Substantive response of the Local Highway Authority to a planning consultation received under The Development Management Order.

Planning Application Number: 25/00523/FUL

Application Address: Wiggs Farm Wood Road Nailstone Coalville Leicestershire LE67 1GE

Description of Application: Re-consultation. The erection of a B8 distribution hub with ancillary offices, quality control office and canopy, maintenance units, and gatehouse, and associated infrastructure and landscaping

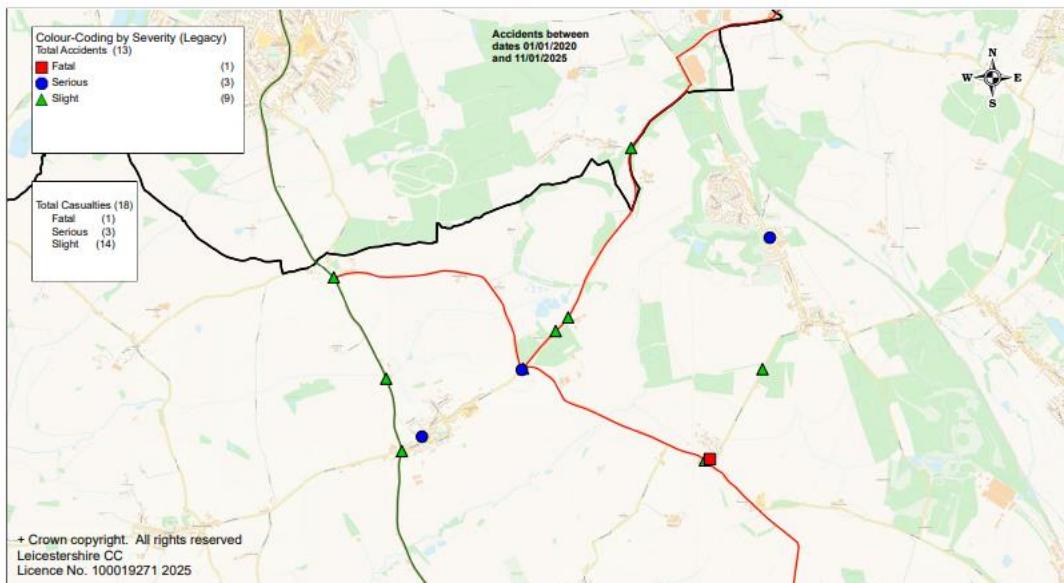
The Applicant should provide dimensions showing that the shared use foot/cycleway widths are in accordance with Table 18 and 19 of the LHDG. The shared use foot/cycleways require a buffer strip in accordance with Cycle Infrastructure Design LTN1-20 Table 6-1.
